WT Young Library Renovation

PROJECT 3050.1

ADDENDUM #6

**WT YOUNG LIBRARY
LOWER LEVEL RENOVATION**

T-100A

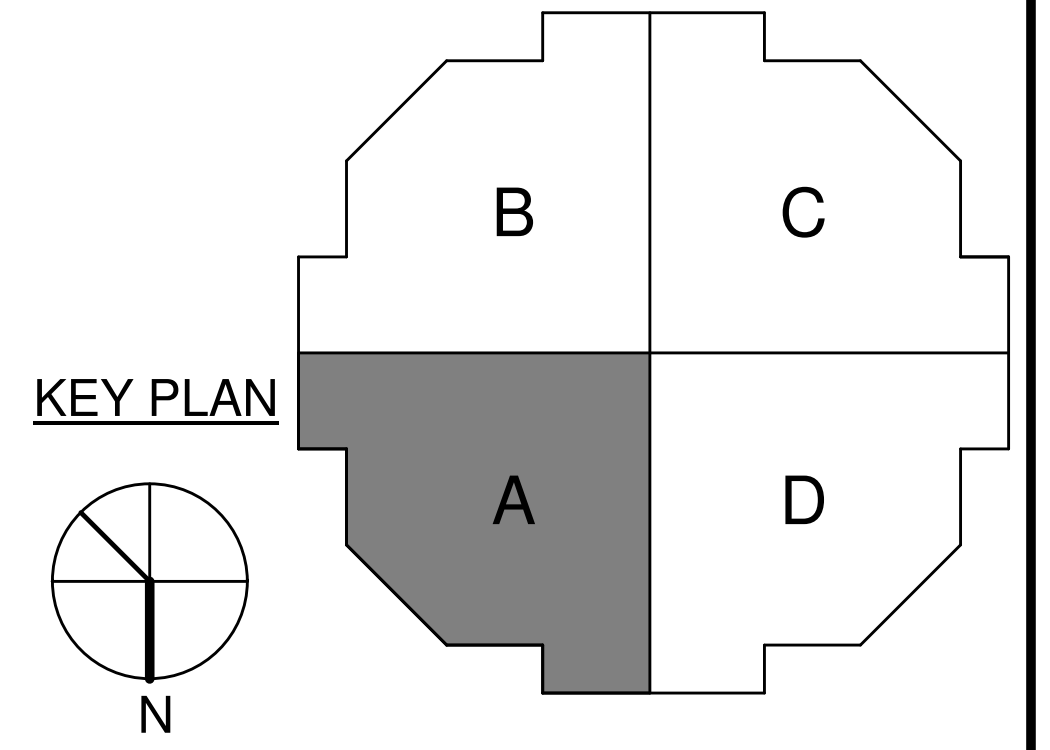
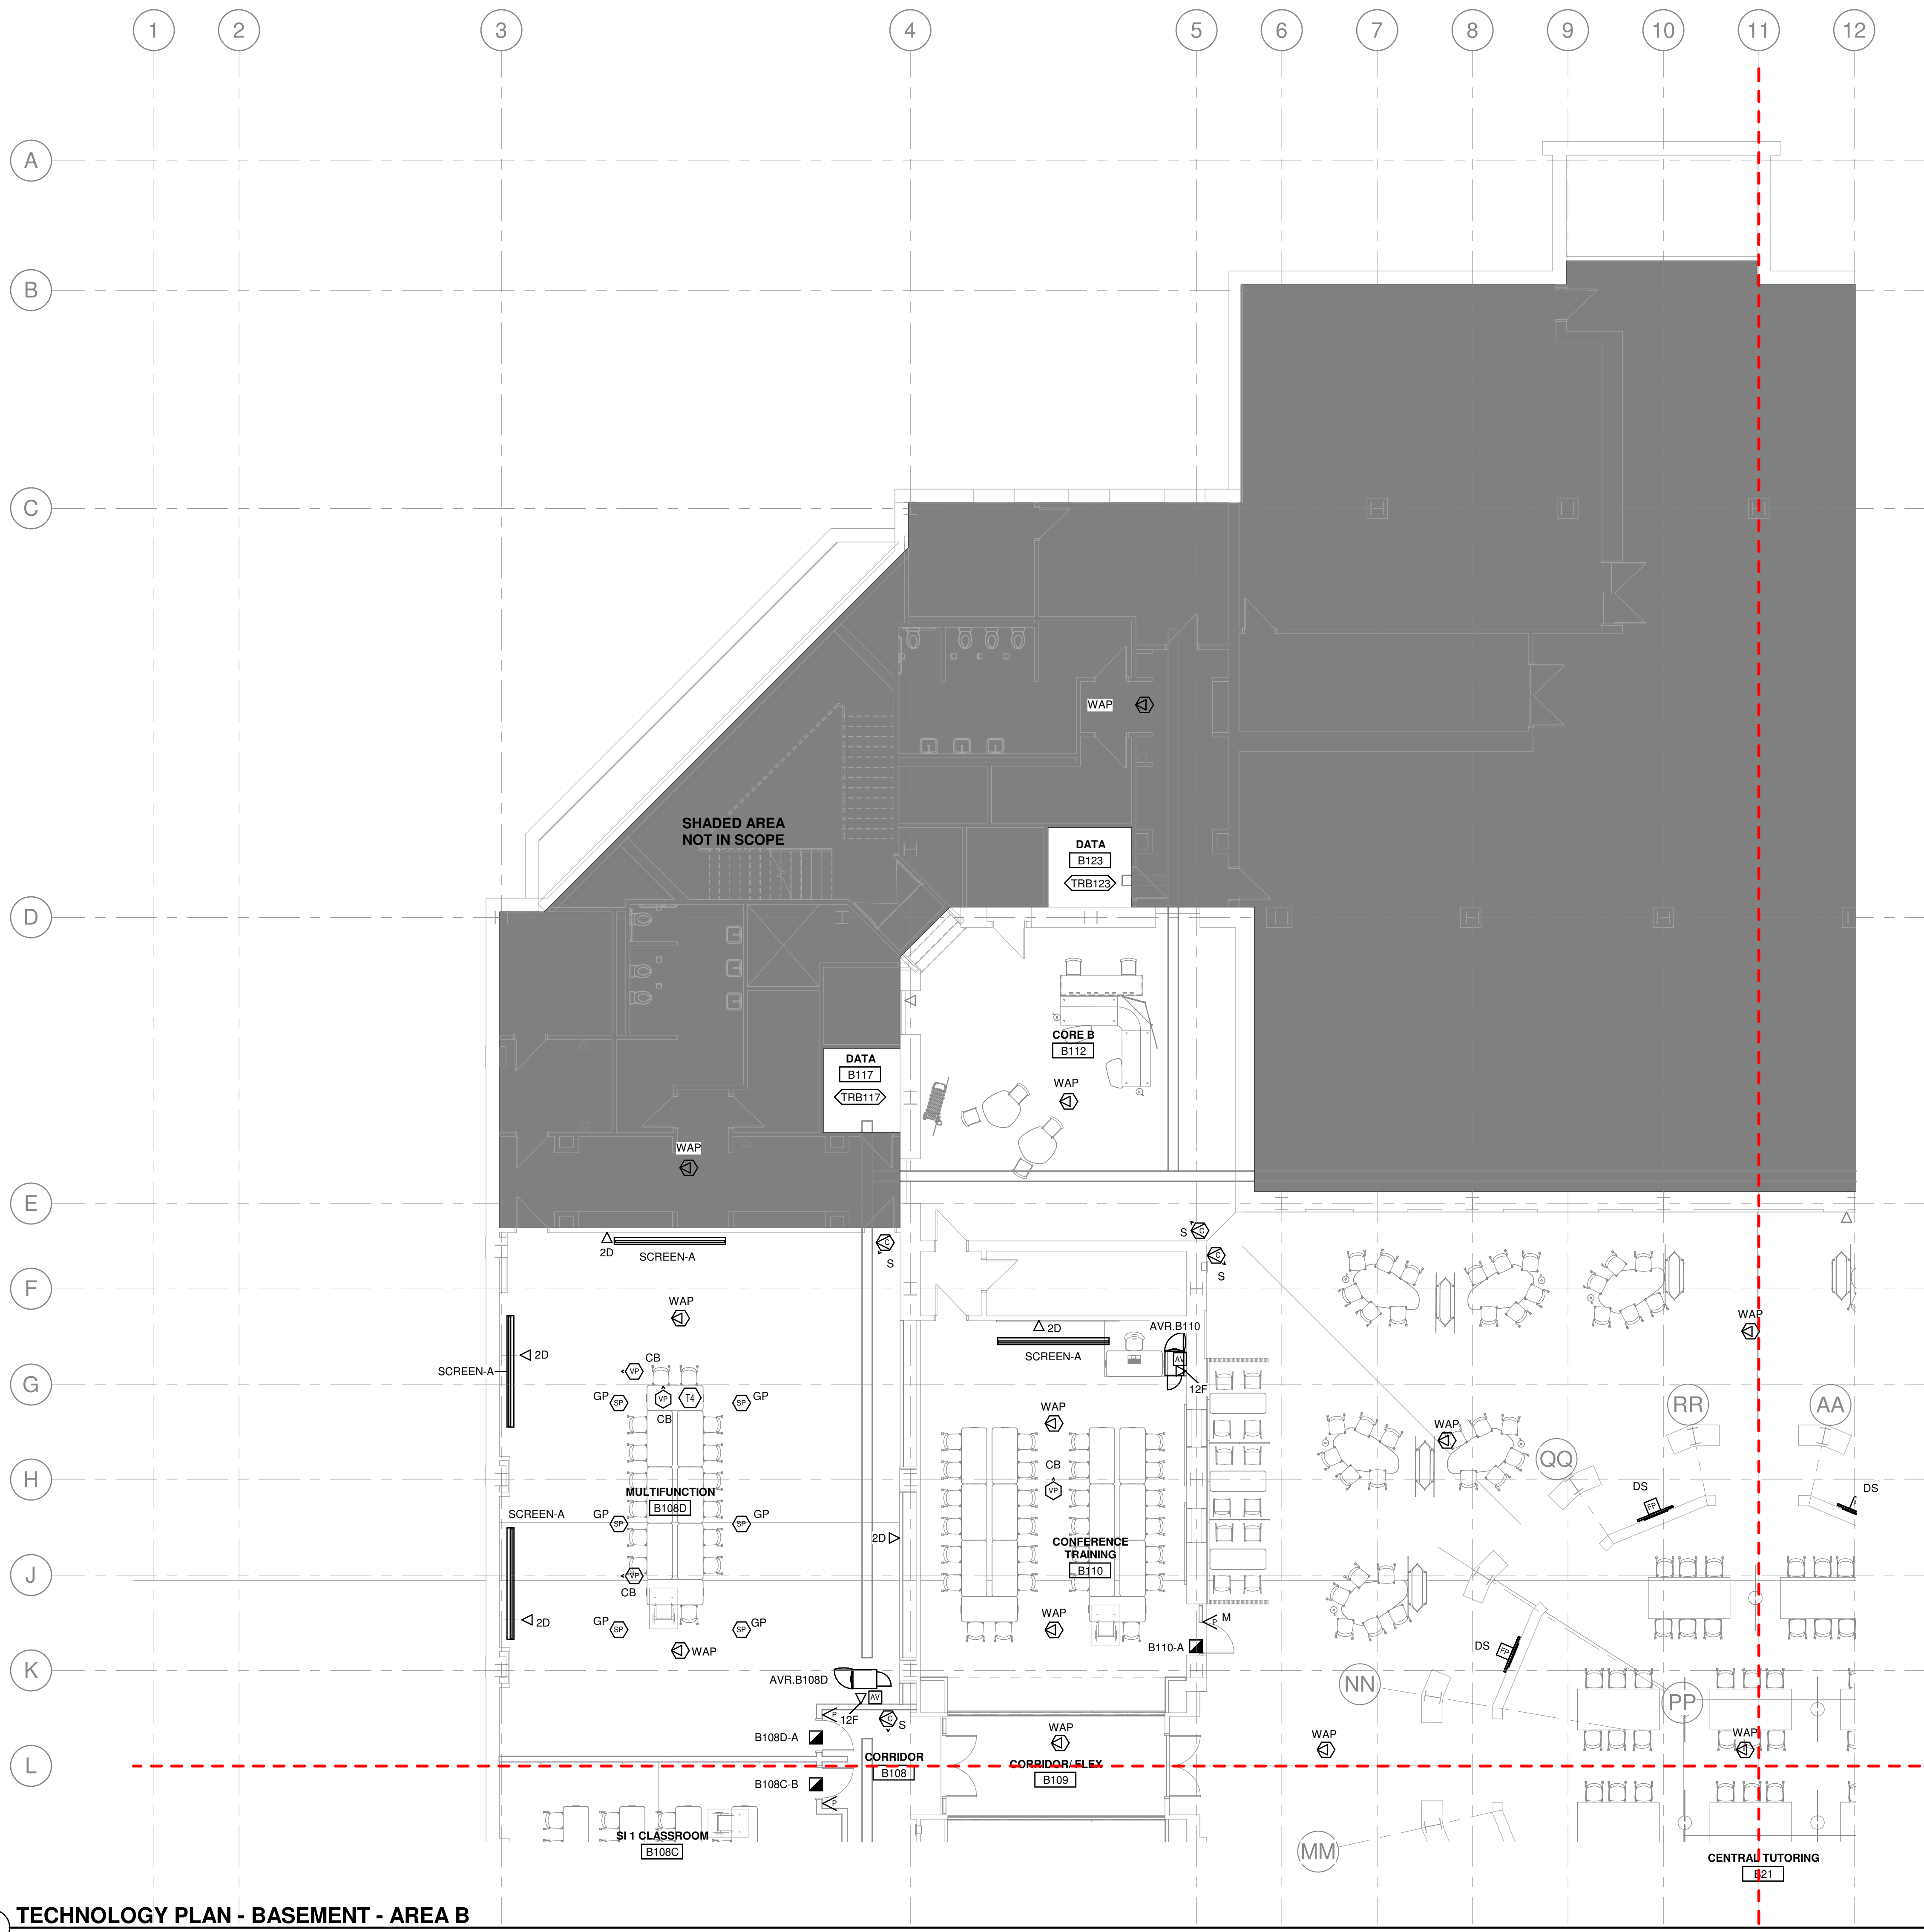
- Sheet T-100A - Technology Basement Plan Area A
 - a) Added control panel location.

T-100B

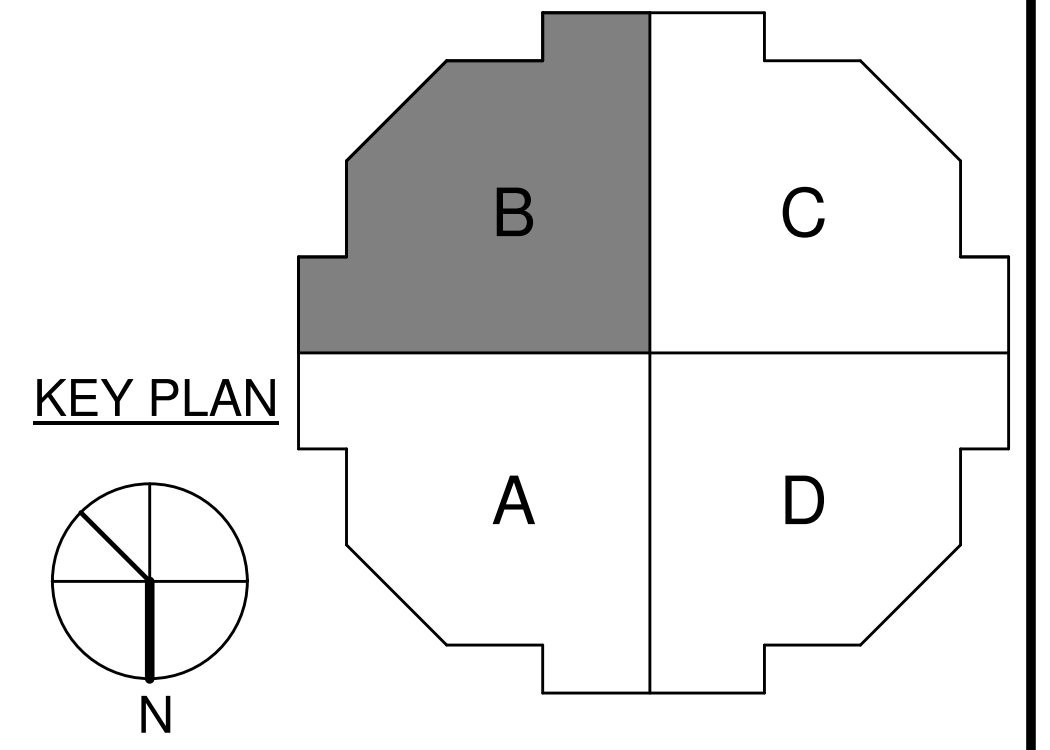
- Sheet T-100B - Technology Basement Plan Area B
 - a) Revised note.

T4 SEE DUAL PROJECTOR SYSTEM DIAGRAM. ADD (1) ADDITIONAL PROJECTOR AND SCREEN. PROVIDE "GP" TYPE SPEAKER INSTEAD OF OR. THESE NOTES ONLY APPLY TO ROOM B108D. EXPAND MATRIX AS NEEDED TO ACCOMMODATE ADDITIONAL OUTPUT.

T-641

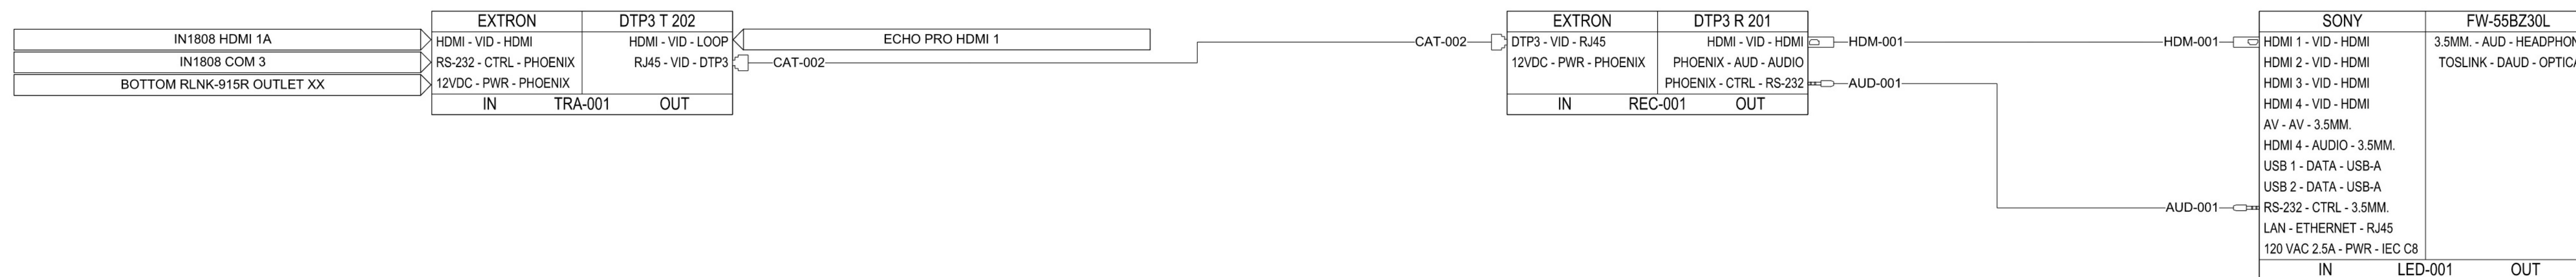
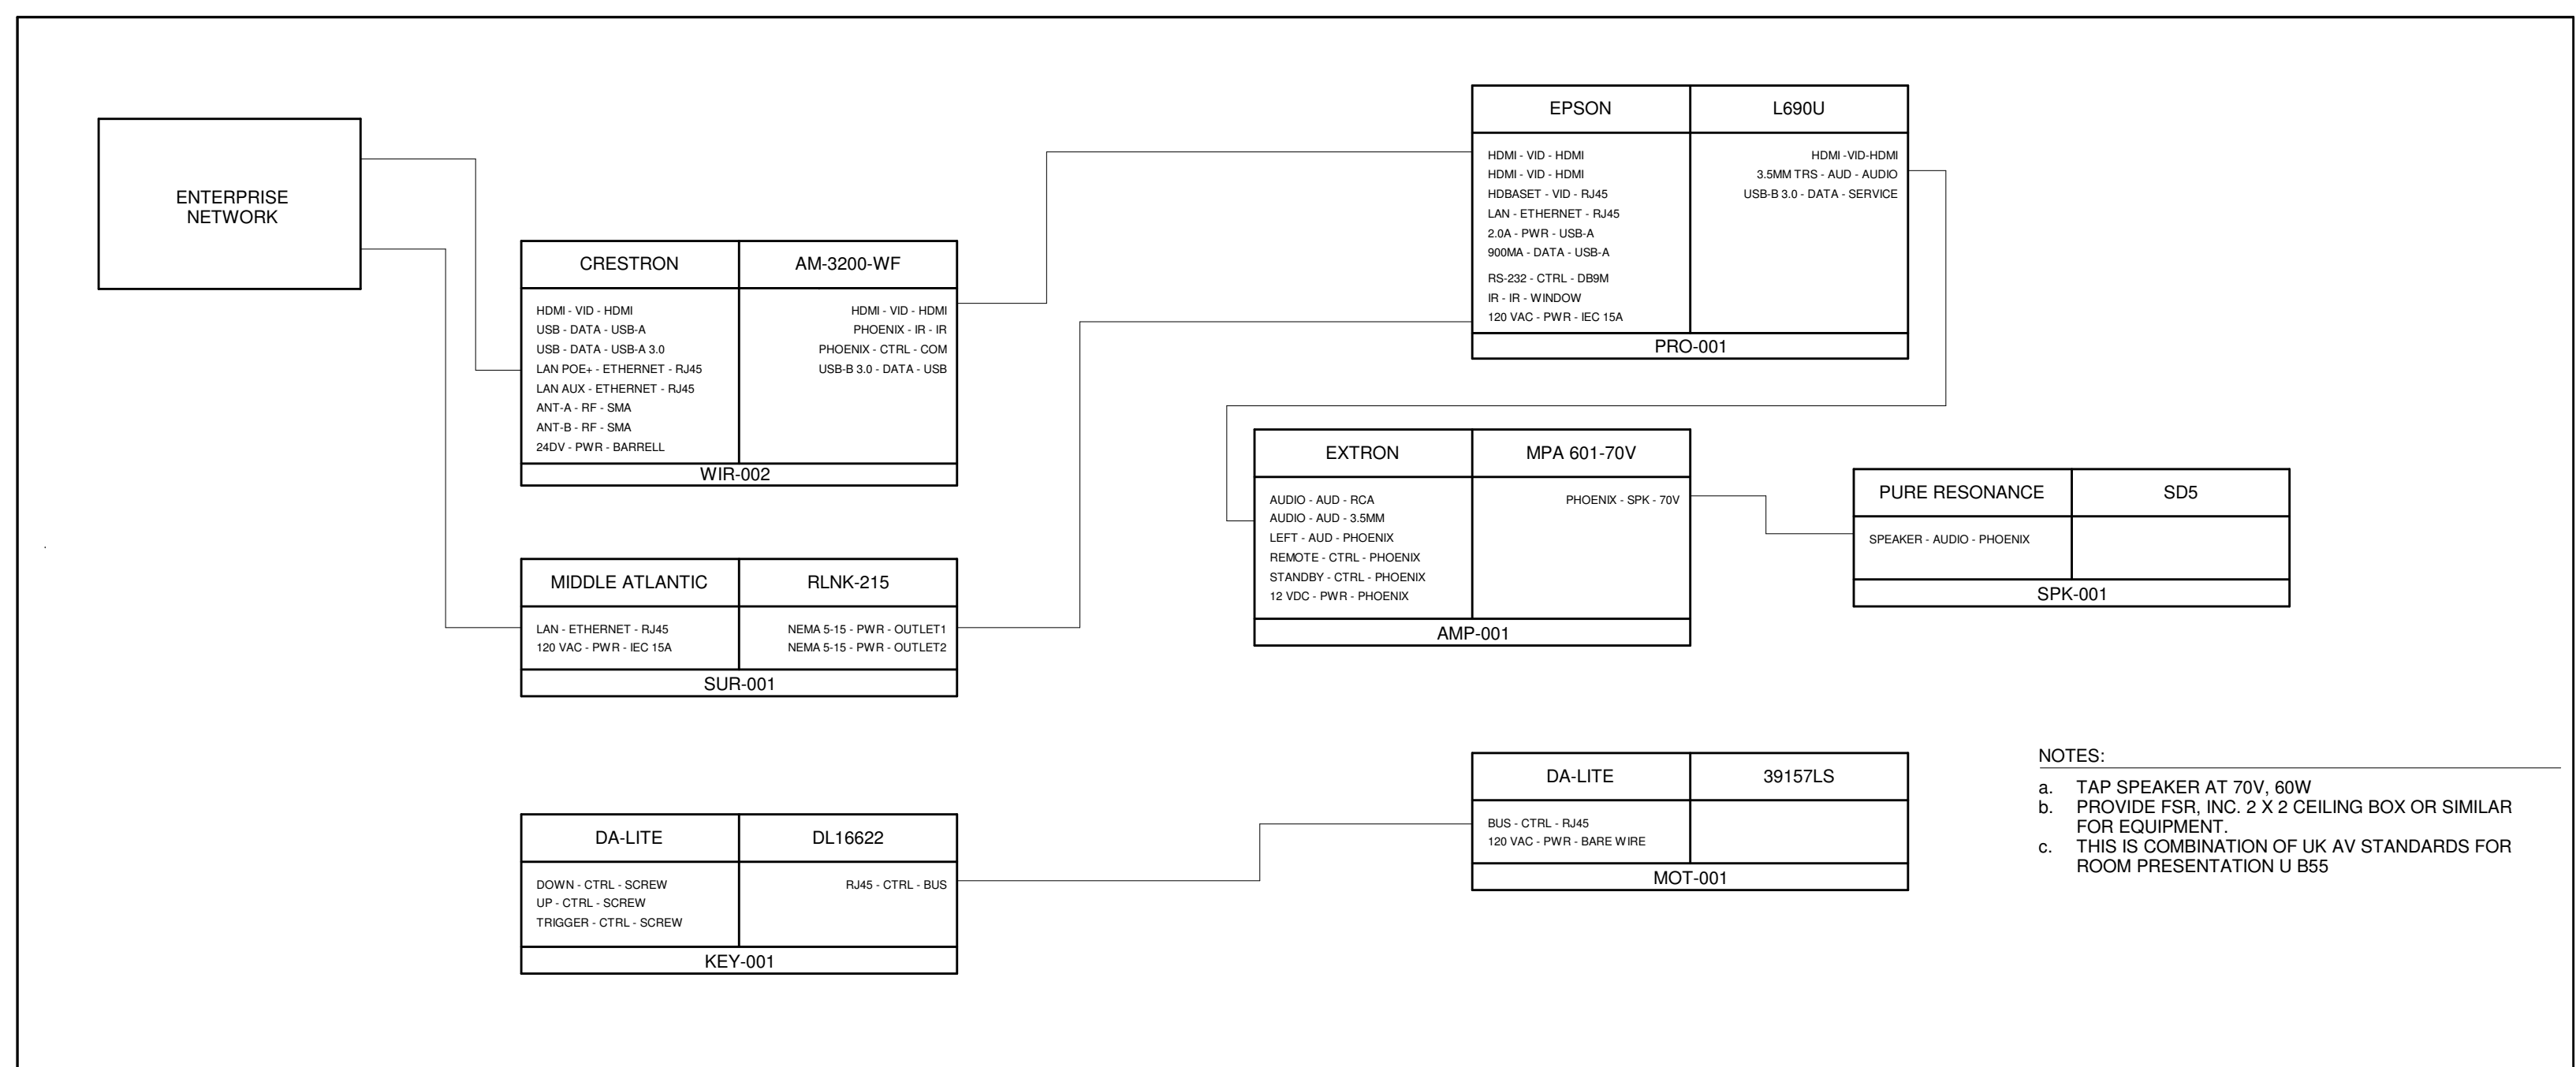
<p>There is a General Note on T-641 that makes reference to the UK AV Standards, but only one Detail on this sheet is per the standard. Is the intent of this bid package to conform to the UK AV Standard in its entirety, or only as depicted in the Plans and Specifications? – The intention is to conform to UK AV standards. The drawings were intended to indicate which standard was to be applied to each space with some specific exceptions.</p>	<p>Deviations from UK standards have been better defined. Intent to adhere to UK standards as close as possible.</p>
<p>T-100A - Group Room B66 shows a Collaboration System Level 3, where is the Touch Screen to be located for this system – Wall mount adjacent to plan north door.</p>	<p>Wall mount adjacent to plan north door.</p>
<p>T-100B - Multifunction Room B108D shows an AV System with three projection screens with Keyed Note to add additional Projector and Screen. Does the size of the Extron DTP3 Crosspoint 622 need to be increased to allow for an additional Matrixed Output or will this projector use a mirrored output from the existing DTP3 Crosspoint 622.</p>	<p>This projector use a mirrored output from the existing DTP3 Crosspoint 622.</p>

- Sheet T-641 - Technology Av Systems
 - a) Revised Collaboration Space Level 3
